Report to the Future Melbourne Committee

Ministerial Planning Referral: TPMR-2019-34

572-574 Lonsdale Street, 256-260 King Street, 248-250 King Street and Gough Alley, Melbourne**Presenter:** Larry Parsons, Head of Statutory Planning**Purpose and background**

MINISTERIAL PLANNING REFERRAL

**SCENARIO 2:
ONE WAY ADOPTED**

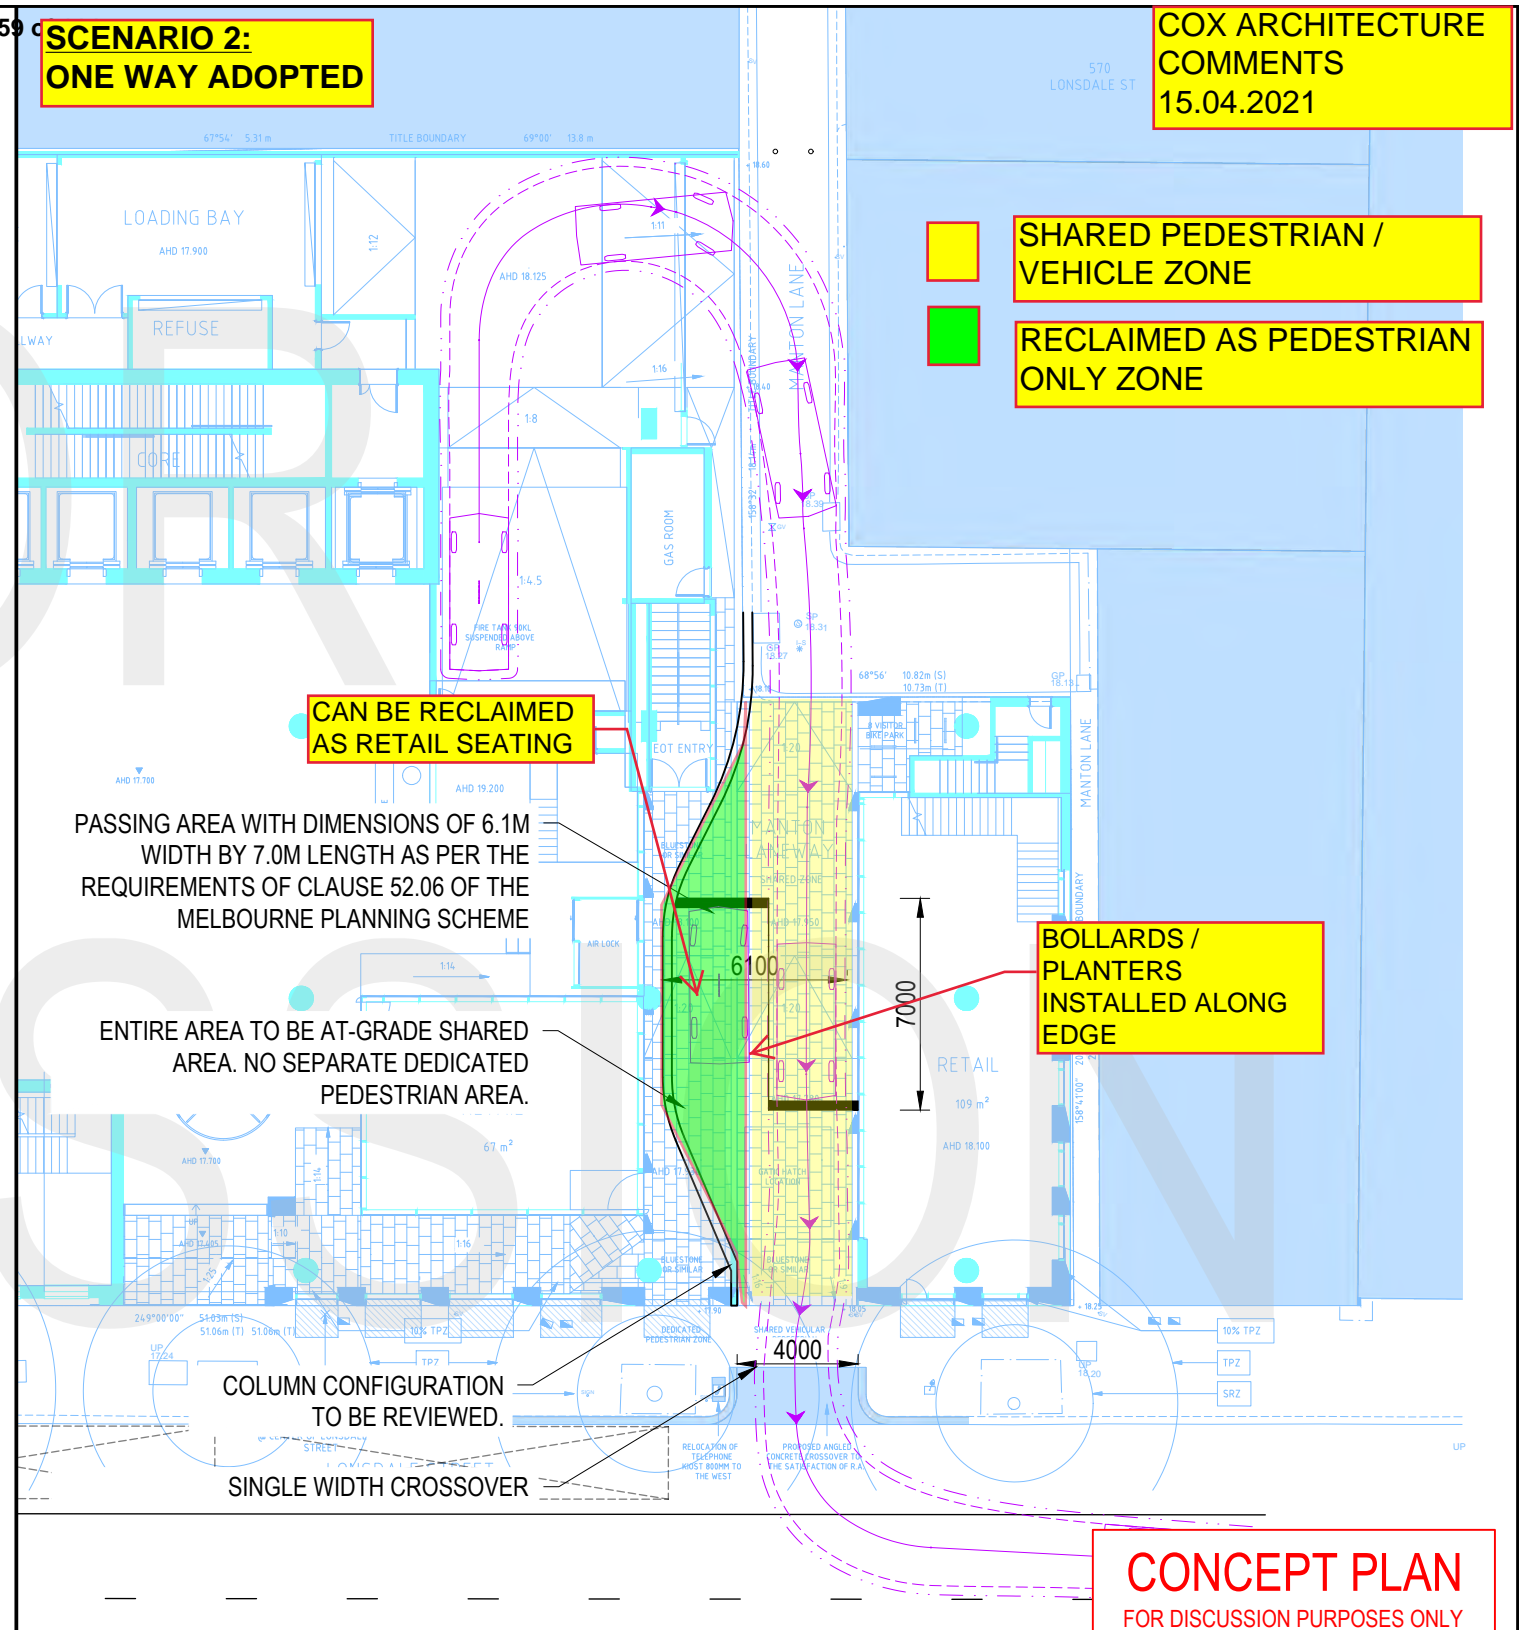
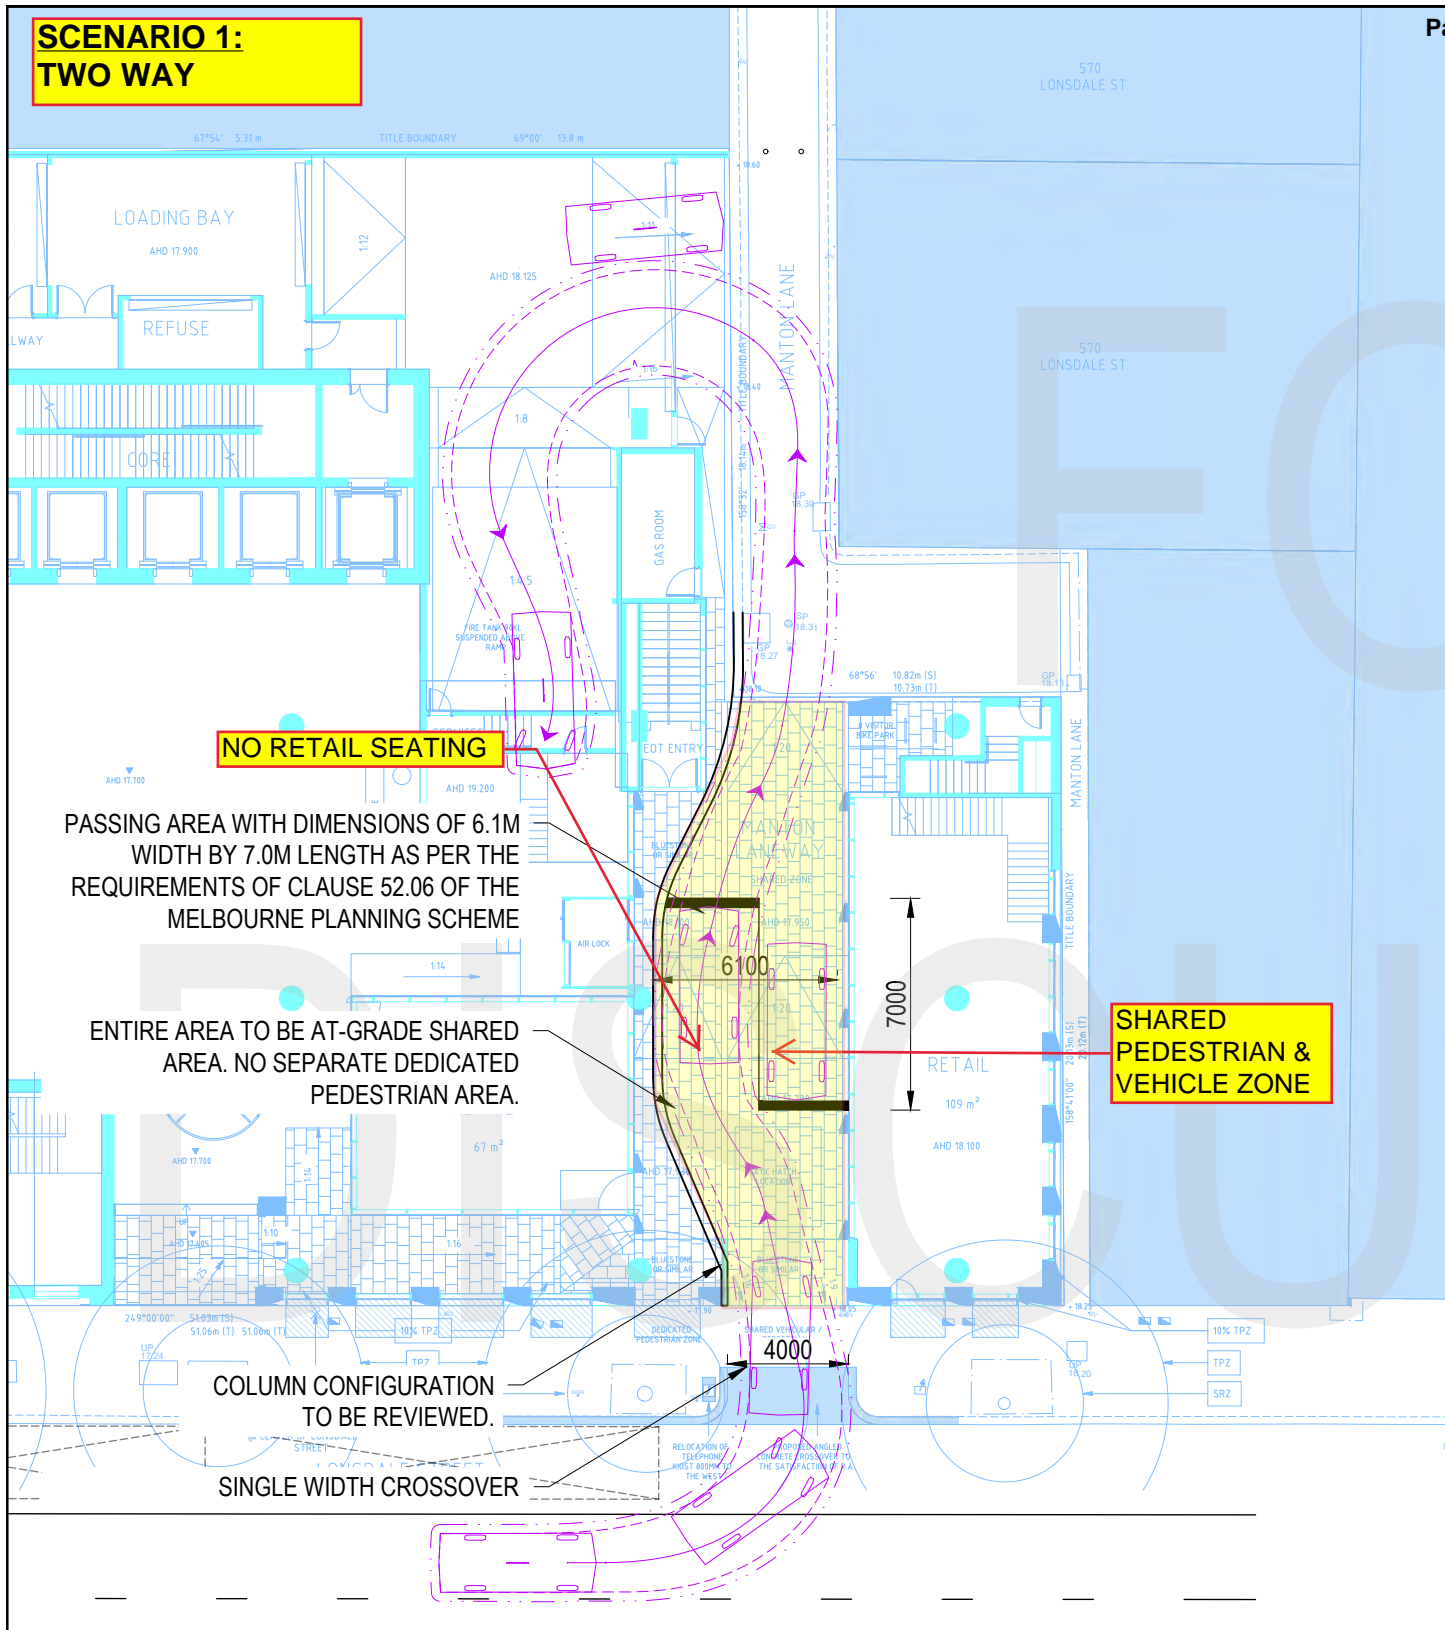
**COX ARCHITECTURE
COMMENTS
15.04.2021**

- SHARED PEDESTRIAN / VEHICLE ZONE
- RECLAIMED AS PEDESTRIAN ONLY ZONE

13. Proposed demolition plan. Cox Architecture November 2020

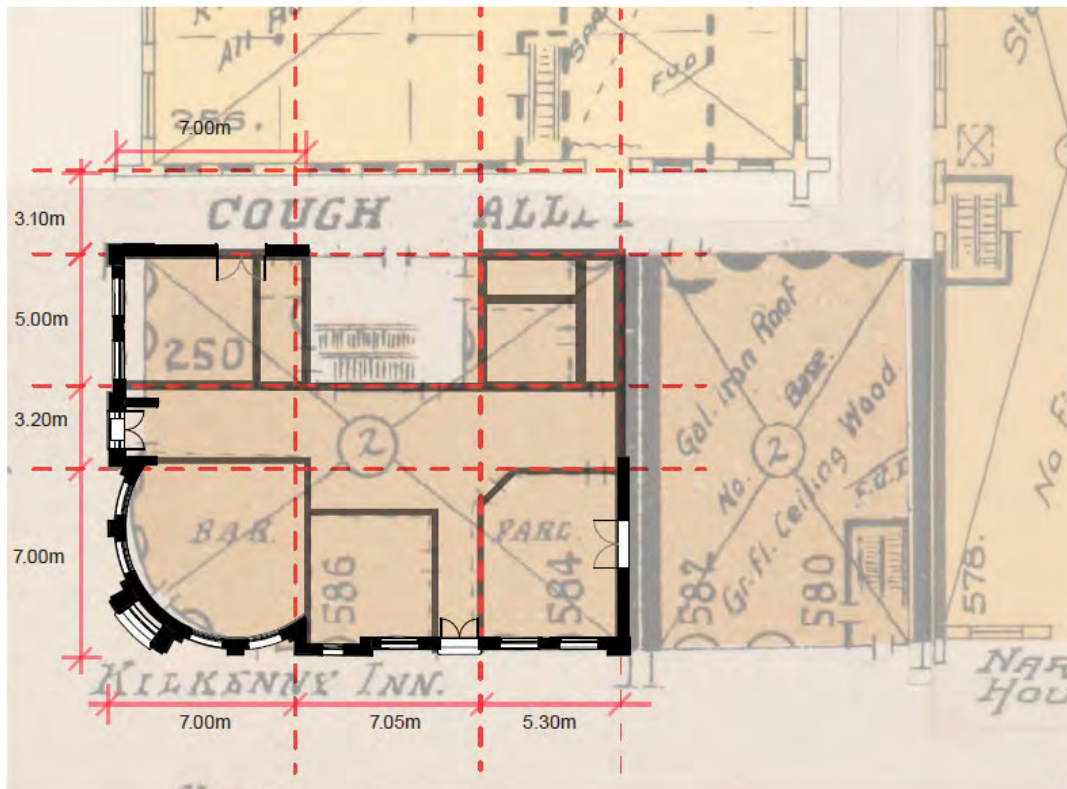
The Urban Context Report by Cox Architecture dated November 2020 states original Parlour, Bar and room facing King Street will be retained however the demolition plans do not demonstrate that these rooms will be retained.

21. Indicative without prejudice ground floor plan showing revised extent of demolition received 26 April 2021

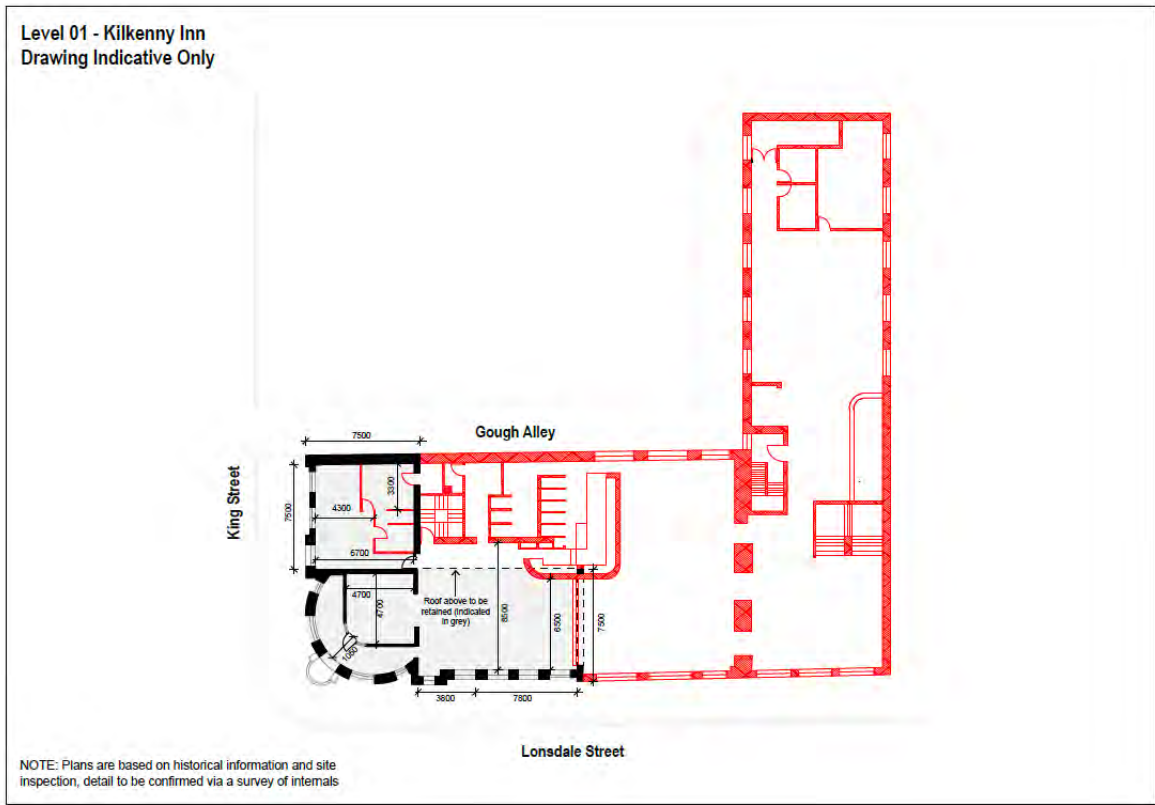
Following feedback received from City of Melbourne in regards to retaining the existing front rooms of the Kilkenny Inn, the applicant provided indicative plans based on historical information and site inspection on 30 March 2021. The following indicative plans were provided on 26 April 2021. These plans were provided on a without prejudice basis.

25. Revised without prejudice vehicle access plan received 20 April 2021

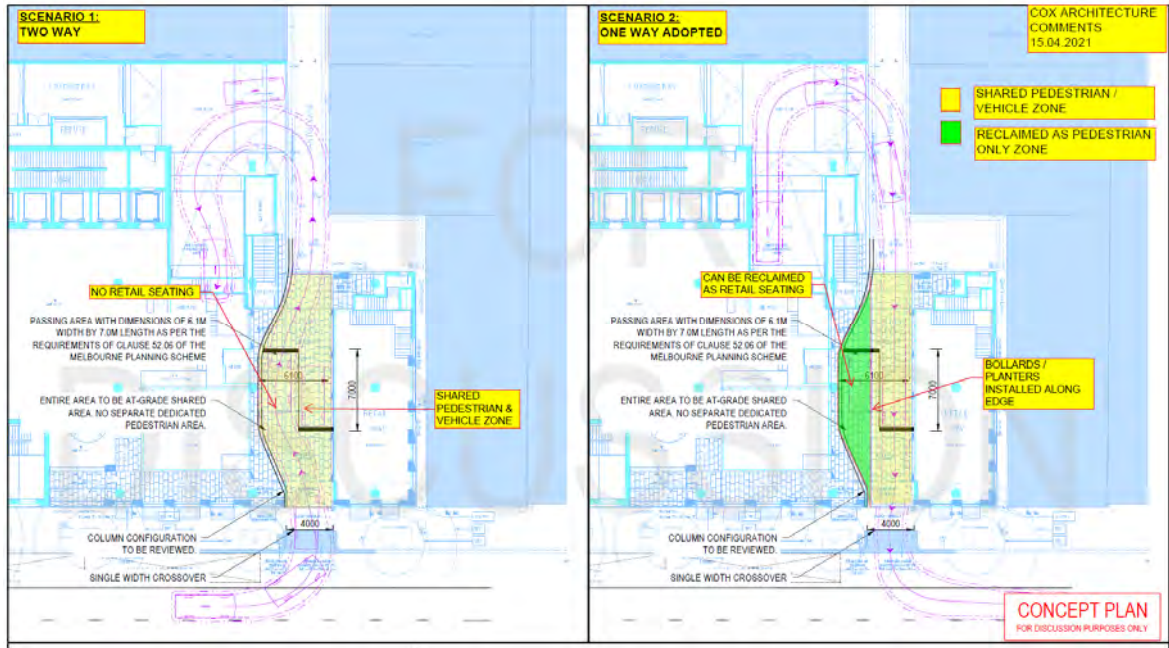
The applicant provided a revised vehicle access plan on 20 April 2021. The revised plan shows changes to the proposed vehicles access arrangements for the Site from one way off Lonsdale Street to two way. This revised vehicles arrangement seeks to address concerns raised by objectors (owners and tenants) at 10-22 Manton Lane, by maintaining two-way access with a widened passing area at the southern end towards Lonsdale Street.

The objectors' concerns relate to vehicles on their site not being able to exit their building in a southerly direction (current vehicle entry and exit being from and to the north in a two-way configuration). If one-way, smaller vehicles will require a 5-point turn across the primary office entry and the laneway and it is not possible for larger vehicles to exit.

The applicant's architect Cox Architecture have also marked the revised vehicle access plan demonstrating how the ground floor widened access way / passing area could be 'reclaimed' for pedestrians in the event that the entire length of Manton Lane were to be made one-way in the future.

Traffic – supportive of the without prejudice plans (revised vehicle access) subject to conditions requiring a double vehicle crossover to Lonsdale Street and alternative measures to the installation of bollards on Manton Lane.
